NOTICE OF THE MEETING OF THE PLAN COMMISSION

AGENDA FOR REGULAR MEETING VILLAGE OF TINLEY PARK PLAN COMMISSION

**ITEM #1 WORKSHOP/PUBLIC HEARING – BREMEN ANIMAL HOSPITAL ADDITION,
7613 159TH STREET – ARCHITECTURE/SITE PLAN APPROVAL, VARIATION**

PLAN COMMISSION STAFF REPORT

A-0.1

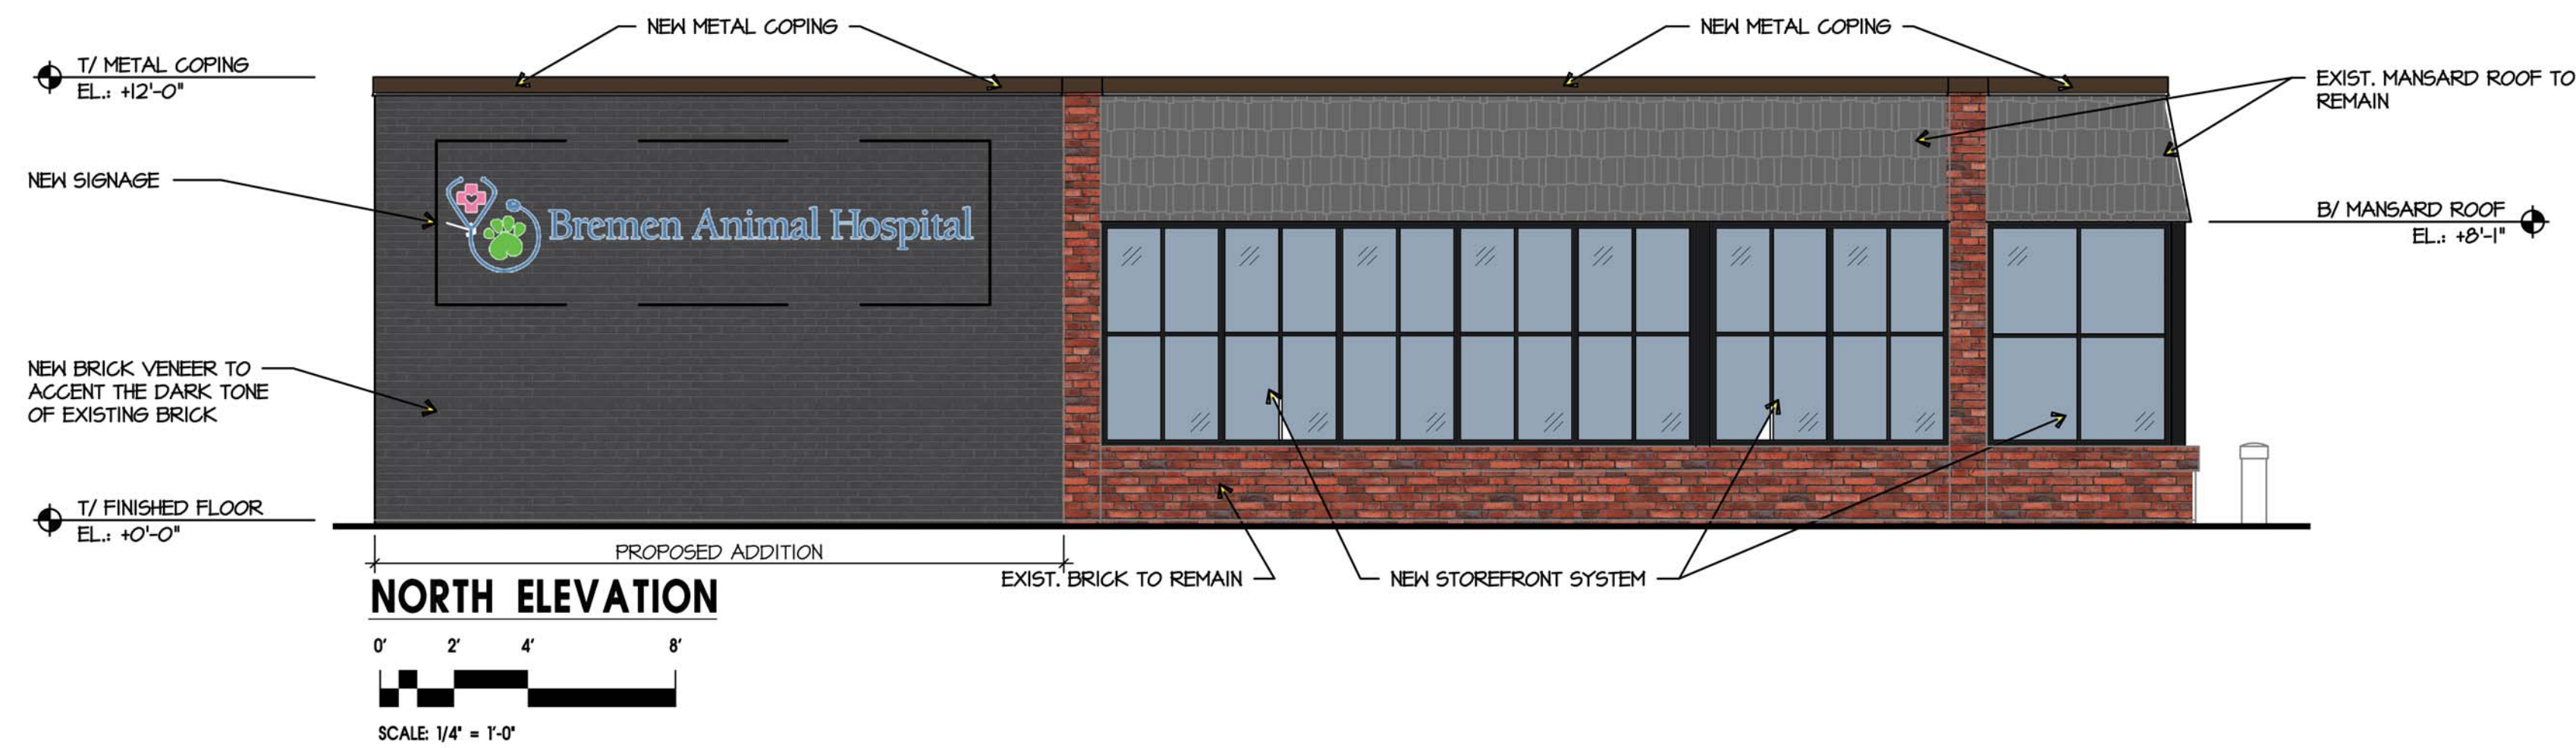
1. There are dimension differences between the plans. Unless directed otherwise we will use the engineer's drawing (Base C1) as having the most accurate dimensions. **Updated architectural site plan to show same dimensions.**

2. On Base C.1- There is a note to remove and replace bollards. Please explain why; are you moving them closer to the building? **The existing bollards are low in height and may not be visible to some drivers, new bollards will be 4'-0" high and painted traffic yellow for high visibility.**

4. What is the distance in a north-south direction of the aisle that is reduced to 20.45'? I want to make the point that this is only a small portion of the drive aisle. Therefore I want to know the area that is 20.45' x ? **The north-south dimension and area has been provided – see site plan.**
